Title		
2P06 DOPPLER FSRX3 WO GYRO		
Size	Document Number	Rev
B	History	<V3.1.B>
Date:	Tuesday, September 02, 2025	Sheet 1 of 7

Title			
2P06 DOPPLER FSRX3 WO GYRO			
Size	Document Number		Rev
A	Function Block		<V3.1.B>
Date:		Tuesday, September 02, 2025	Sheet 2 of 7

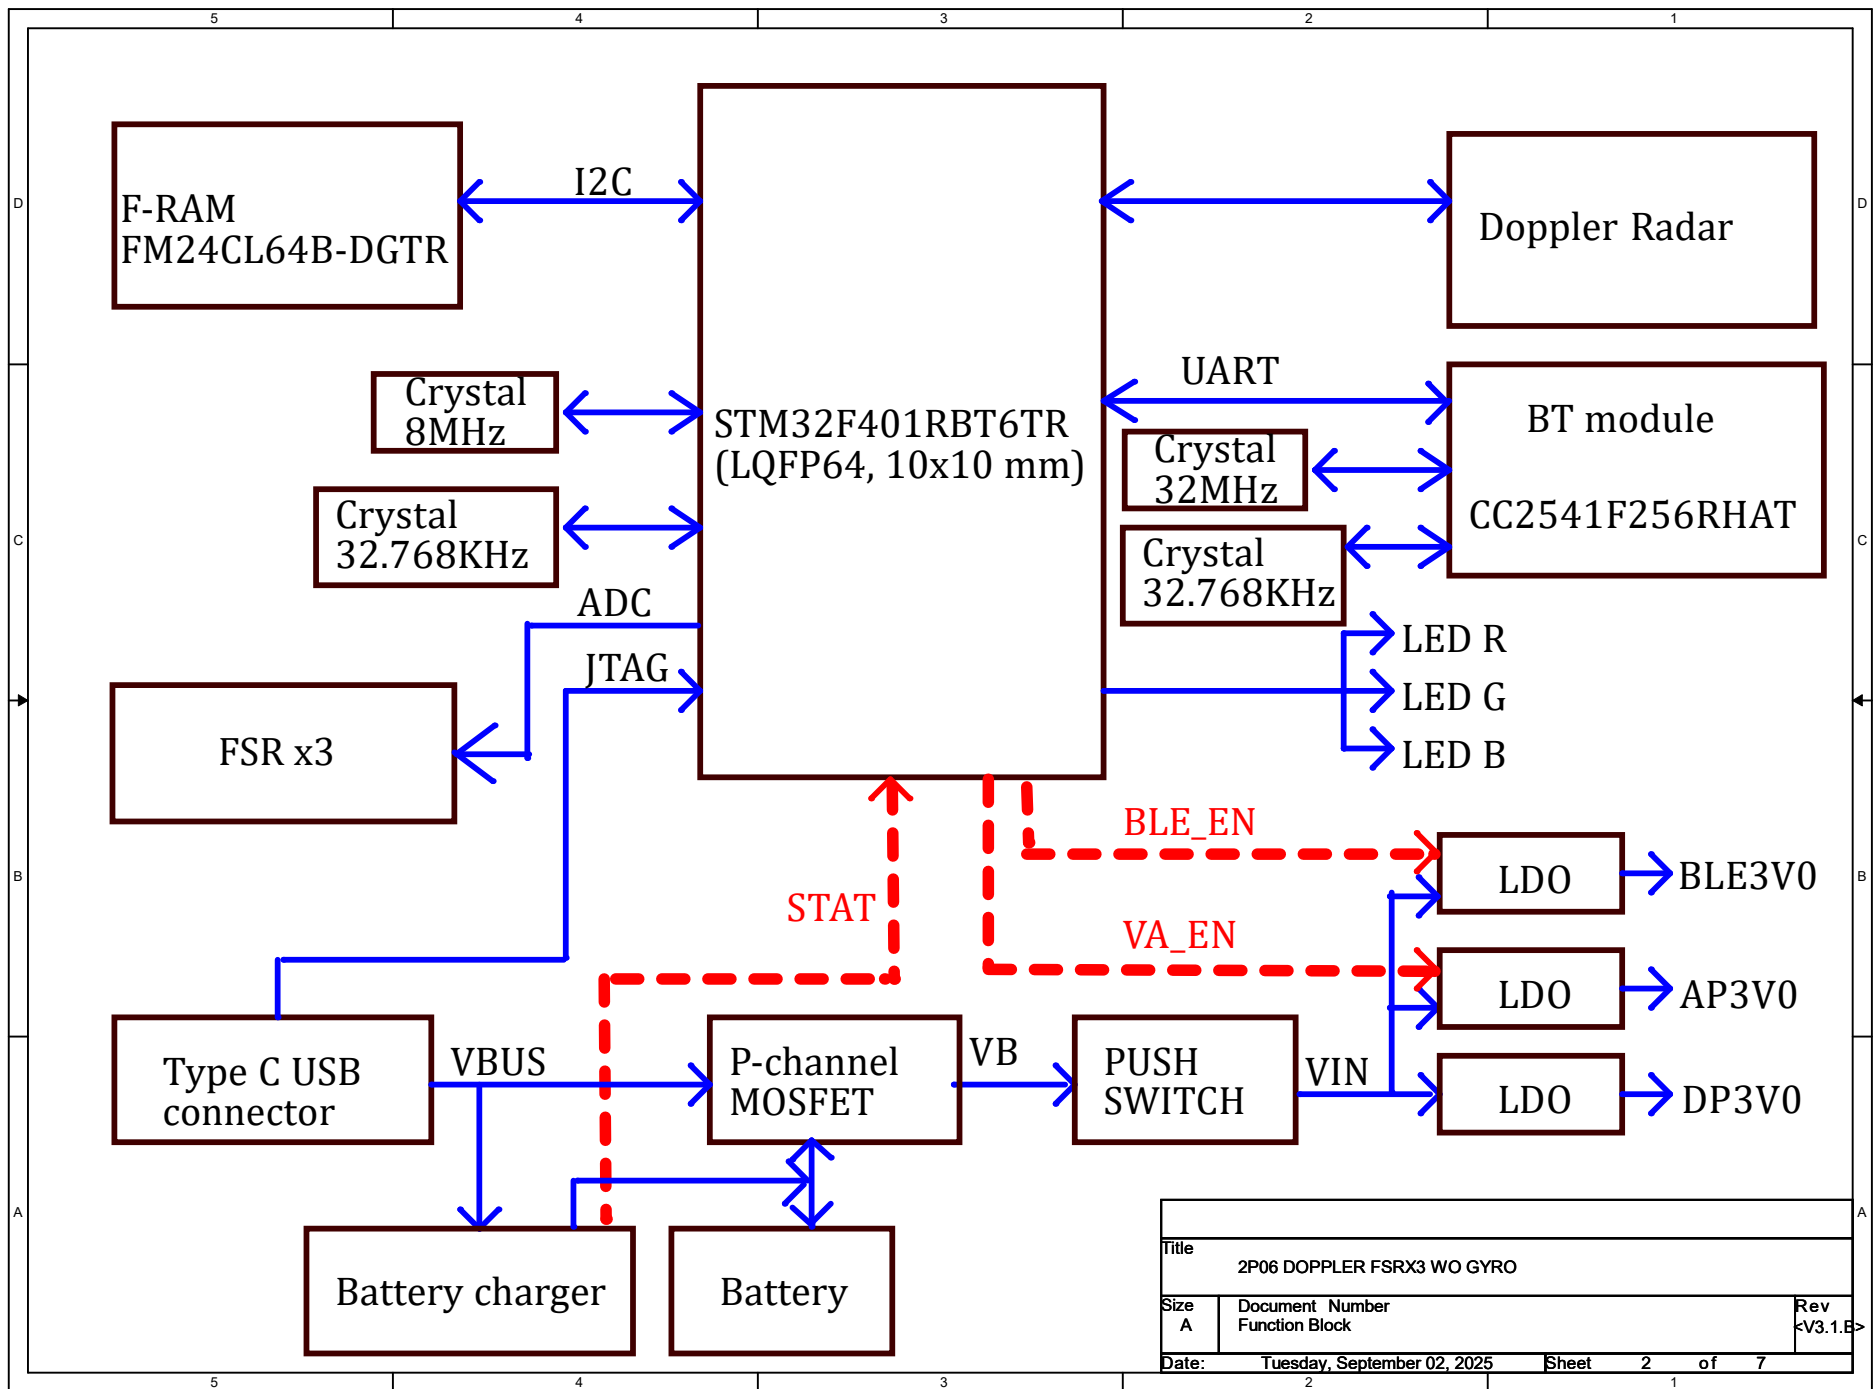
20230217	V0	Initial
20230609	V1	Requested by Dr.Lin, Change design as below 1.Change q'ty of LED from 1 to 4 2.Change TACT SWITCH to PUSH SWITCH : SP20-058AH1 3.Change 2 pins x3 FSR connector to 1 x 6 connector : WF-0600RSxx-S304 4.Change P/N of Type C connector to : PUBCTQ-24FLBS143 Modify value of resistor by debug M482 1.Change R15 from 510K to 220K Function improvement 1. Add Charging protect circuit
20230615	V1.B	After replied by mechanism, the direction of P1 plug-in need to be rotated 180 degree in draft placement. For trace rouint, pins of P1 are need to swap - Pin 1 (Doppler_RX) swap with Pin 6 (ADC1_IN5) - Pin 2 (Doppler_TX) swap with Pin 5 (ADC1_IN3) - Pin 3 (DP3V0) swap with Pin 4 (ADC1_IN2)
20230707	V2.A	After Debug , There are somethings need to be modified below : - Use SW1 to Power ON/OFF system 1.Delete SW1.3 from NET " WKUP" and add a test pad for NET " WKUP" 2.Delete SW1.1 SW1.2 from NET "DP3V0" 3.Change NET "VBATT" to "VIN" 4.Seperate "VBAT" from "VIN" 5.NET "VBAT" include SW1.1, SW1.2, R99.2, U19.3, U19.7, U19.8 - Correct Layout error 1.Change 2 tooling holes from R1.1 mm to R1.5 mm

20230907	V3.A	After Debug , There are somethings need to be modified below : 1.SW1 " SP20-058AH1" is wrong material. Correct it with switch with lock 2.Change net name "VBAT" to "VB" 3.Modified connection of SW1 - Connect R200.1, R201.1 to VIN - Connect SW.2 to VB - Connect R200.2 to SW.1 - Connect R201.2 to SW.3 4. Add R22, R23 for I2C1_SCL, I2C1_SDA Here are request from customer below 1. Add Balun TF2 "LFB182G45BG2D280" as 2nd source. TF1 ON, TF2, R210, R211, R212 OFF TF2 ON, R210, R211, R212 ON, TF1 OFF 2. CON1 use new component- 1.0T-1-nAW_6P 3. Use new mechanical drawing "TM_01_PCB_A_20230913.DXF"
20231215	V3.B	Requested by Ken (宏 塑) , modify Silkscreen Only 1. Add outline of battery on Top silkscreen
20250902	V3.1.B	Requested by ITRI, 1. Put crystal in the function block page
